Re: Five-Year Permit Renewal, Coastal States Energy Company, Skyline Mine, ACT/007/005, Folder #3, Carbon County, Utah

PERMIT RENEWAL TECHNICAL ANALYSIS AND STATE DECISION DOCUMENT

COASTAL STATES ENERGY COMPANY
SKYLINE MINE
ACT/007/005
CARBON COUNTY, UTAH

STAGE DISCHARGE CURVE

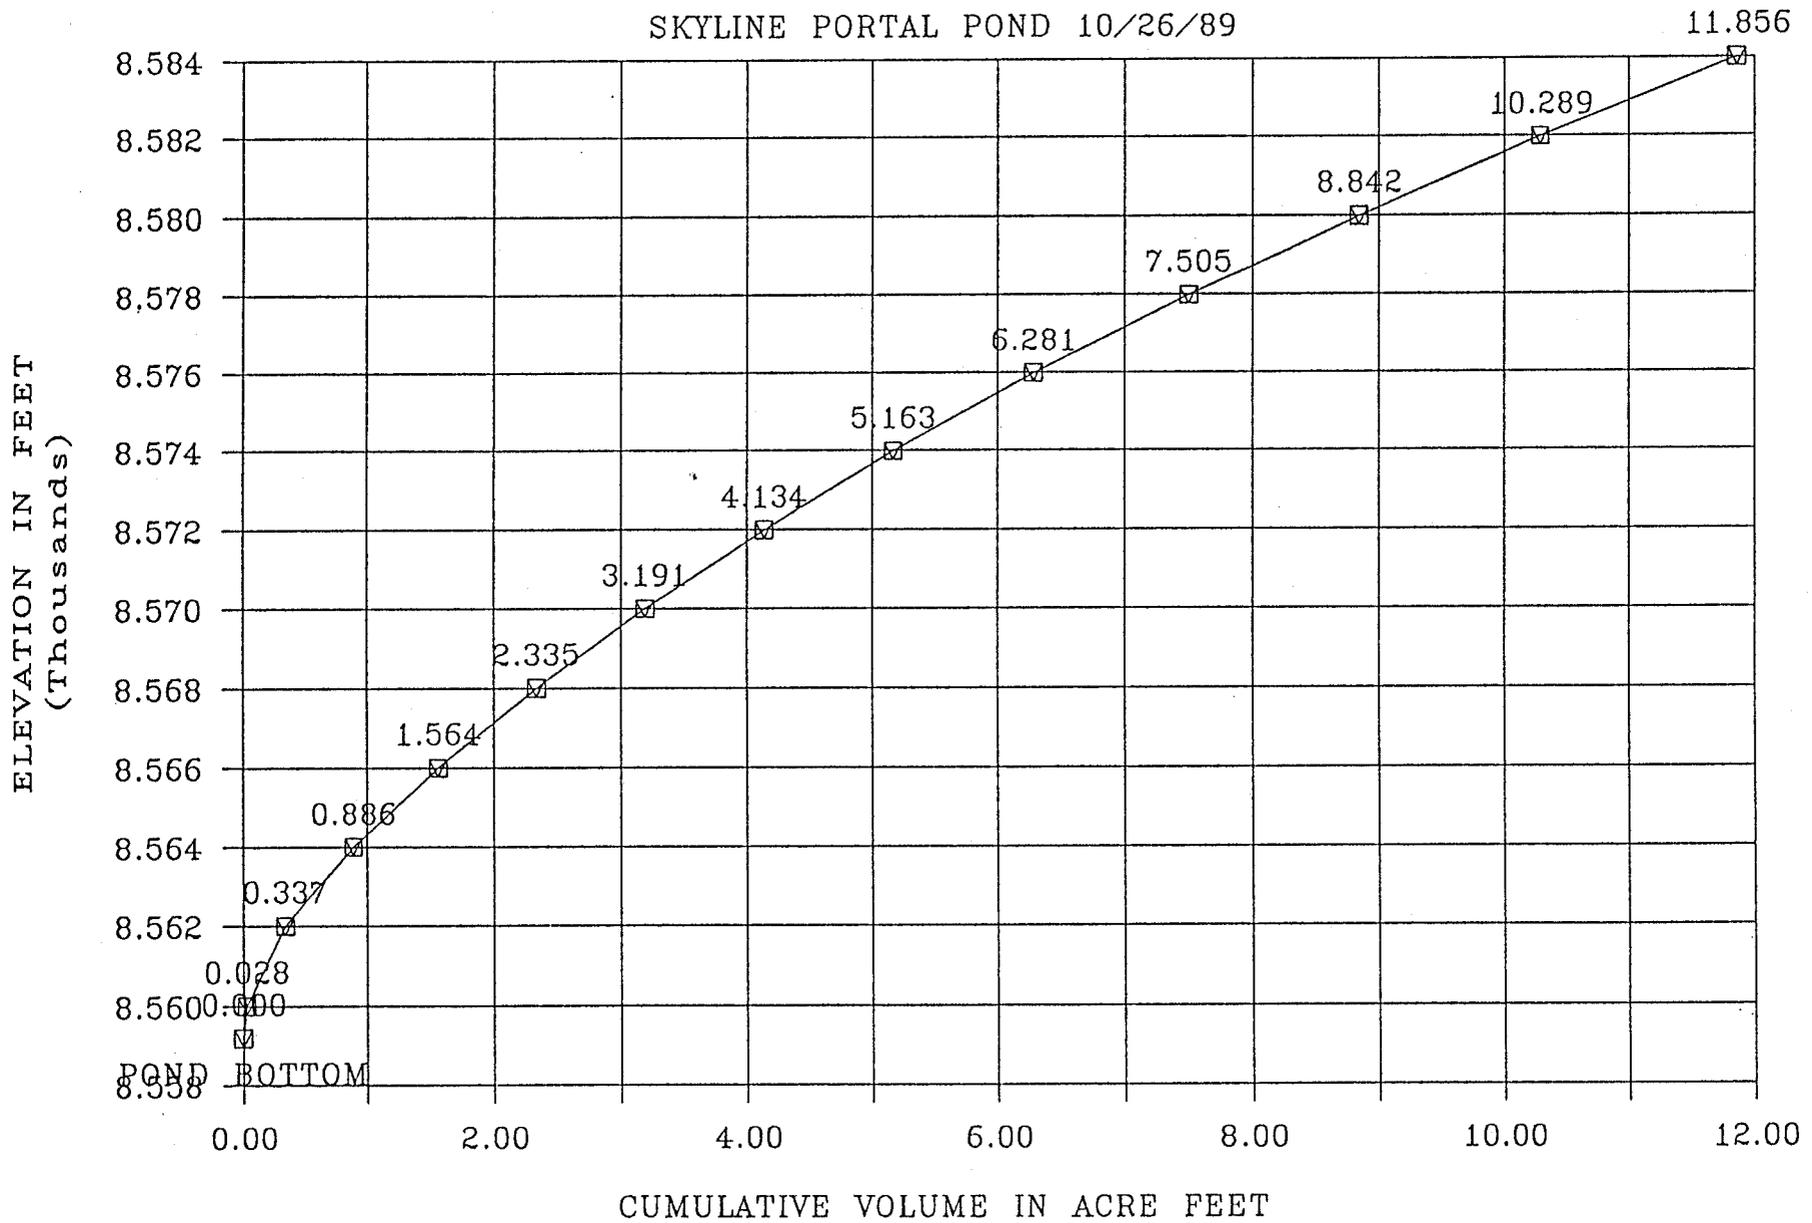
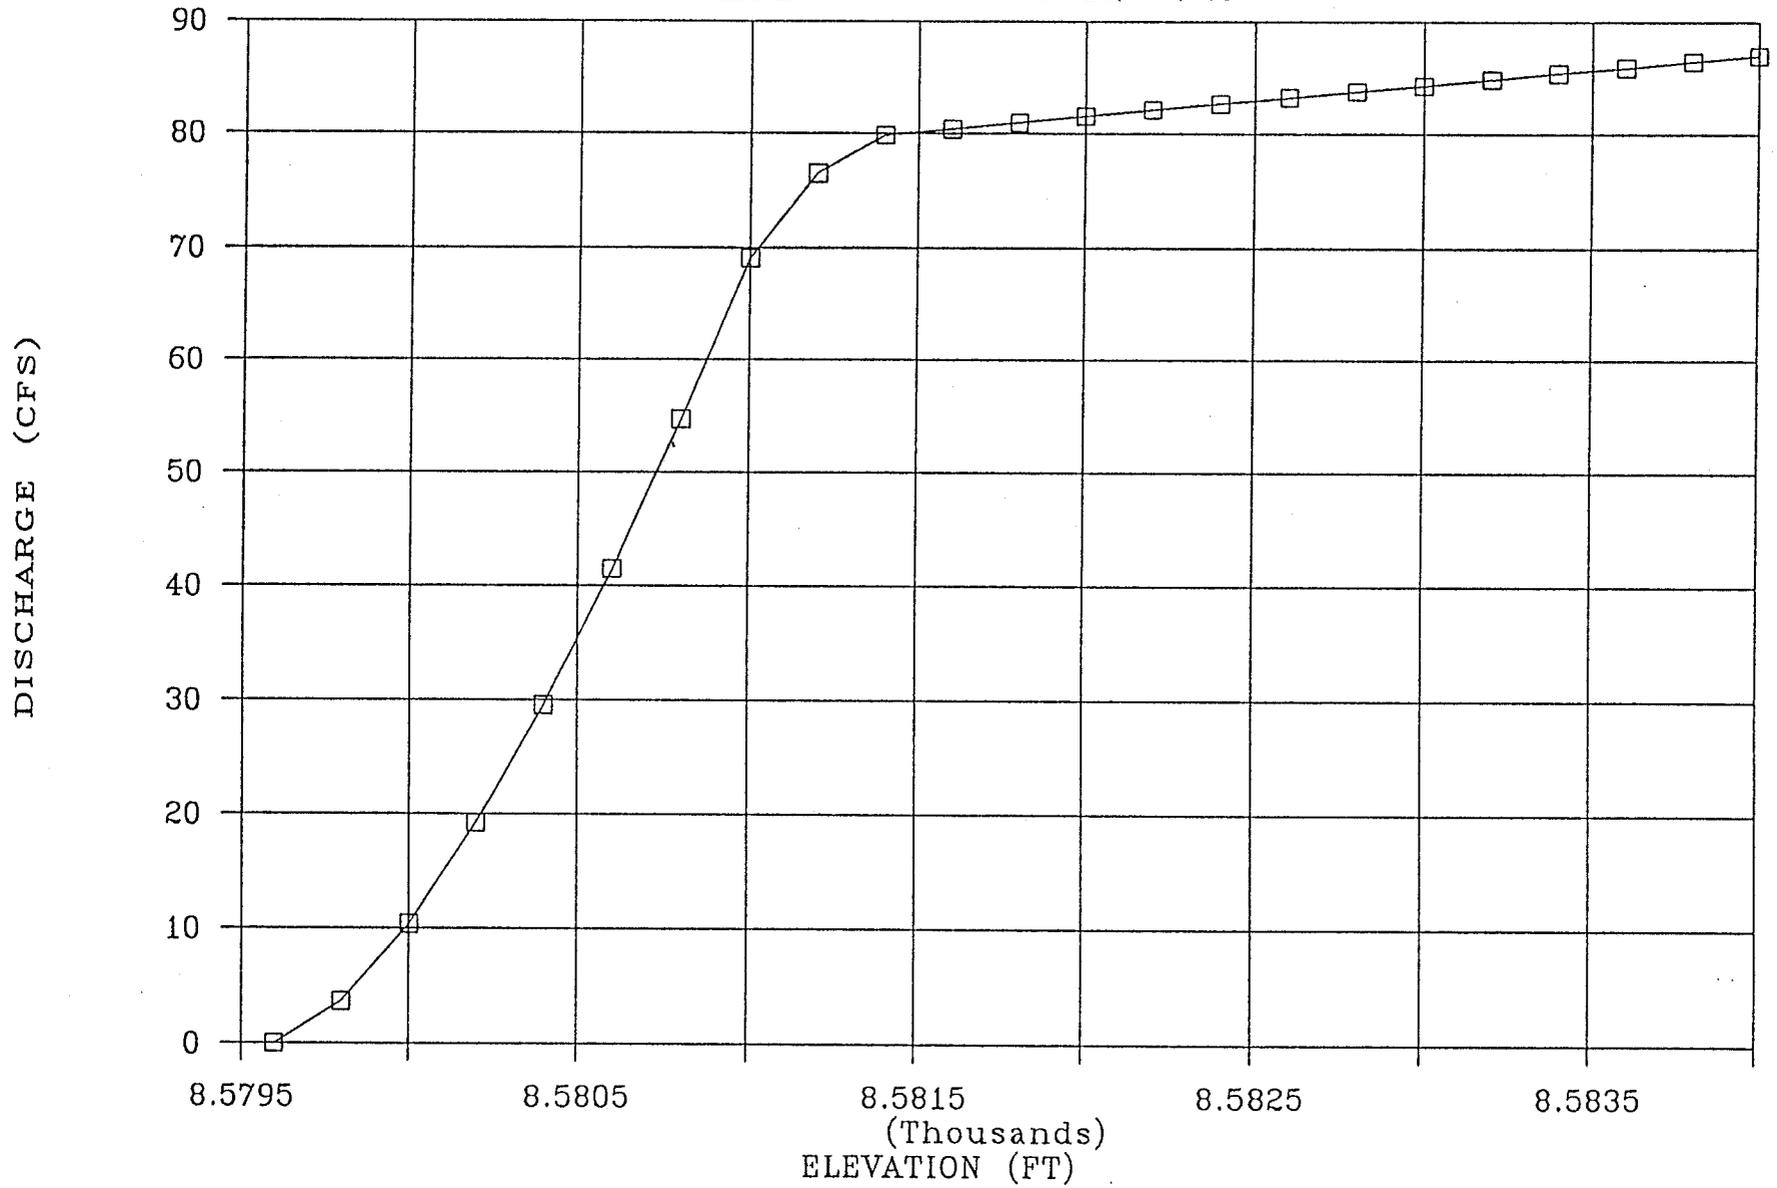
Analysis conducted by the Regulatory Authority using information provided in the MRP indicates that the sediment pond may have a volume available for mine water discharge that is less than the reported value in the application. The Regulatory Authority has discussed this issue with the applicant and it is apparent that the design and calculations can be revised to more accurately reflect the existing sedimentation pond system. The pond performance relative to total suspended solids and settleable solids limitations has been acceptable to date. Stipulation UMC 817.46 - (1) - RS is required to revise the information presented in the application to more accurately define the sedimentation pond function.

1. Prior to June 1, 1990, the applicant must submit revisions to the mine facilities area sediment pond design as necessary to demonstrate compliance with UMC 817.46 and UMC 817.49. These revisions may include revised mine water discharge values, drainage area values, sediment volume and yield predictions, stage - volume calculations, and detention time modeling.
2. Within 90 days of permit issuance, the permittee shall submit an adequate design for a spillway system for the loadout area sediment pond to be installed during the reclamation period.
